Village of Arlington Heights
Plat and Subdivision Committee
Community Room, 3rd Floor
Arlington Heights Village Hall
33 S. Arlington Heights Road
Arlington Heights, IL 60005
July 13, 2016
6:30 PM

Item: Belmont Ave./Haven St. Subdivision - T1550

Item: Marathon Gas Station - 1706 W. Northwest Hwy. - T1560

To: Plat and Subdivision Committee
Prepared By: Sam Hubbard, Development Planner
Meeting Date: July 13, 2016
Date Prepared: July 8, 2016
Project Title: Marathon Gas Station Redevelopment
Address: 1706 W. Northwest Highway

Table 2 - Neighboring Lot Sizes

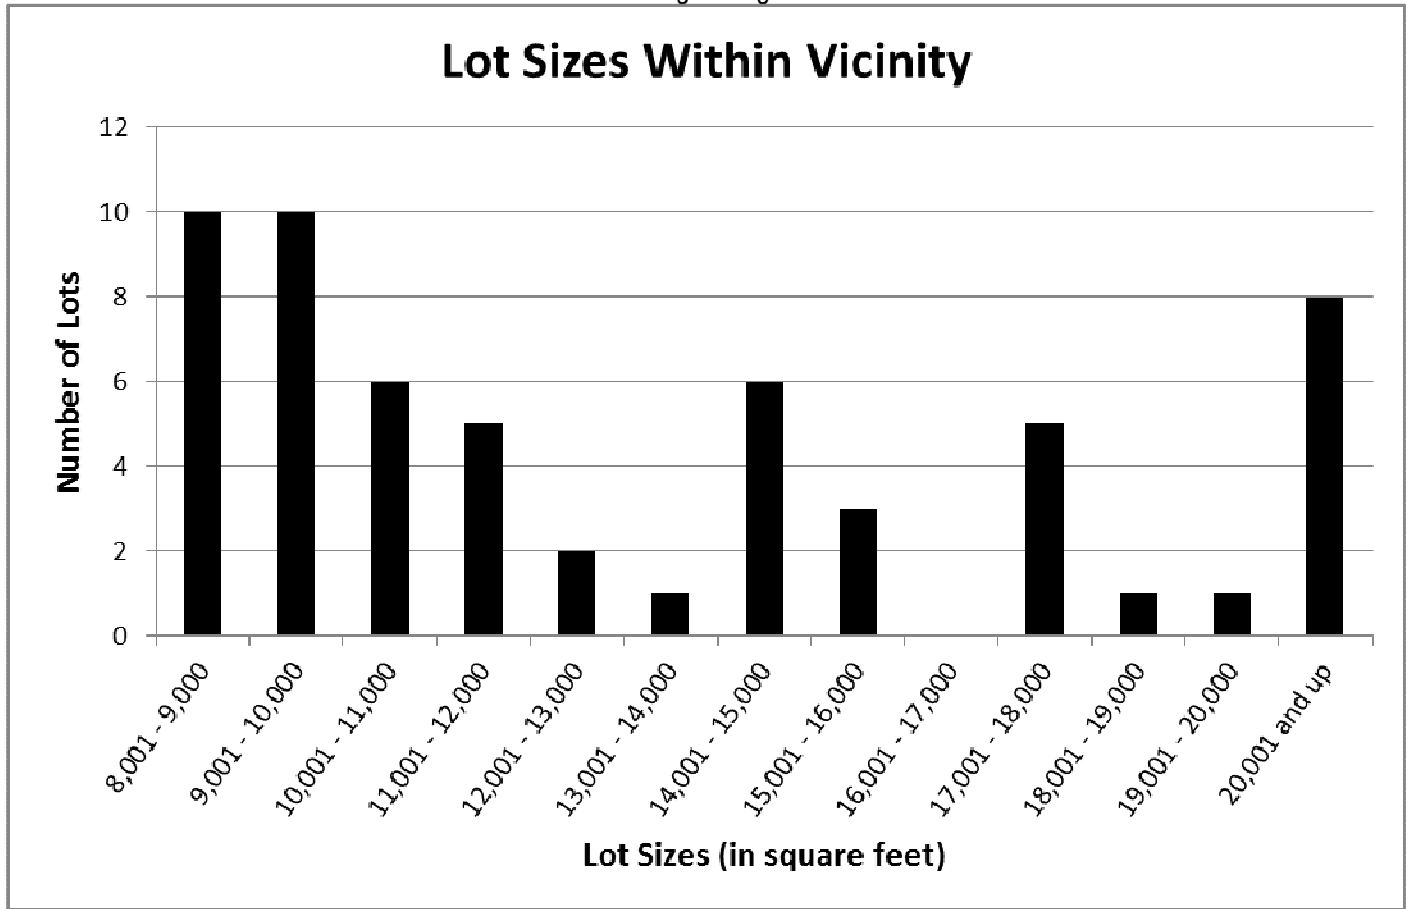
As the majority of lot sizes are within the 8,000 sq. ft. to 12,000 sq. ft. size, the proposed subdivision is of a similar intensity when compared to surrounding developments within the vicinity.
